Planning Commission  
City of Lafayette

Bike East Bay has reviewed the revised designs for a proposed new roundabout at Pleasant Hill Road and Olympic Blvd and still has many concerns about this overly car-centric project. We support the roundabout in principle and appreciate that Lafayette is taking a lead in bringing a modern roundabout to the East Bay. Other cities are watching Lafayette on this. And staff are listening and responding to our concerns, and that is appreciated as well.

**Figure 1003.1A**  
**Two-Way Class I Bikeway (Bike Path)**

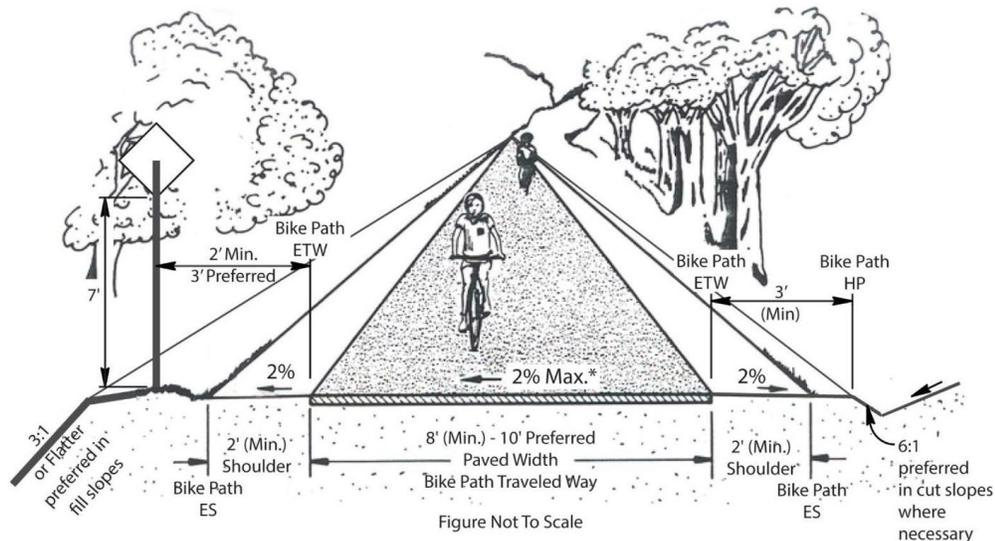
guidelines. See <http://www.dot.ca.gov/Documents/2014-4-2-Flexibility-in-Design.pdf>. The brand new MassDOT design for roundabouts with separation between bicycles and pedestrians is reason enough for such innovation, that is, if Lafayette seeks to incorporate best practices. We are not going to see better roundabout designs in California until local jurisdictions such as Lafayette start innovating, or at least incorporate best practices from other states. In addition, the *NCHRP Report 672 Roundabouts an Informational Guide* acknowledges at Section 5.2.4 “A bicycle–pedestrian conflict occurs at the point where the bicyclist gets onto the sidewalk or shared-use path.” These conflicts can be avoided by separating the bikeway from the pedestrian travel way.

- b. CA Highway Design Manual 1003.1 also states “However, experience has shown that if *regular pedestrian use* is anticipated, separate facilities for pedestrians may be beneficial to minimize conflicts.” (emphasis added). If staff applies the same traffic forecasting rules to bicycle and pedestrian traffic, we all should be able to agree that in staff’s design year 2040, this roundabout will have *regular pedestrian use*, if it does not already. Thus, separation is needed. Section 1003.1 also states the minimum and preferred design widths for paths is 2-8-2 ft minimum and 2-10-2 preferred, the 2ft being shoulders. The *NCHRP Report 672 Roundabouts an Informational Guide* also states that shared paths in roundabouts should be 10 feet wide. Section 6.8.2.2. The proposed design should meet the preferred design guides of 10 feet and in fact should exceed them, as many other multi-use paths around the East Bay are being designed to do, in cities such as El Cerrito, Richmond, Berkeley, and Martinez.

**Exhibit 6-66**  
Crosswalk Alignment Options

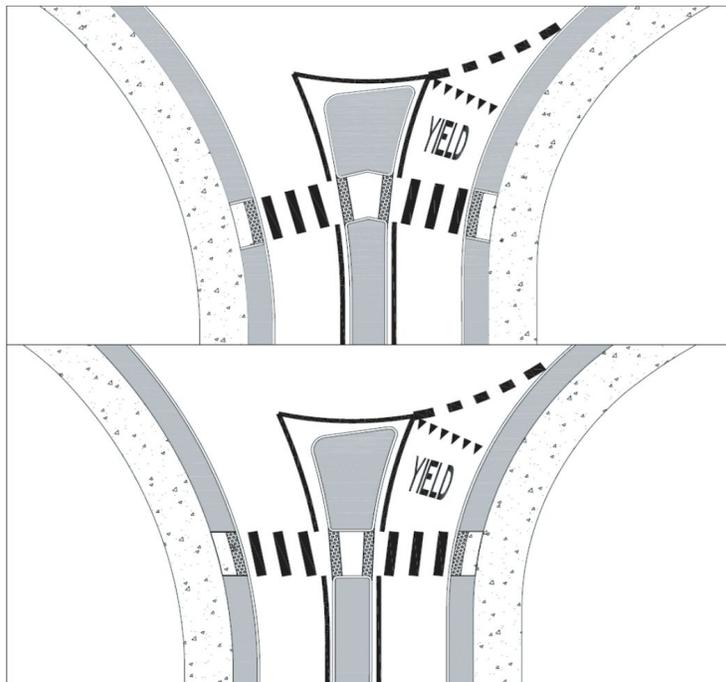
It is of note that the *NCHRP Report 672 Roundabouts an Informational Guide* does not show any dog-legged crosswalks in Section 6.8.1.2., shown here. This national publication shows aligned crosswalks, either straight or slightly angled. Bike East Bay prefers the second of these options as the crosswalk is more direct, but either are good, and both are much better than the doglegged crosswalk, which takes precious space from separated bikeways.
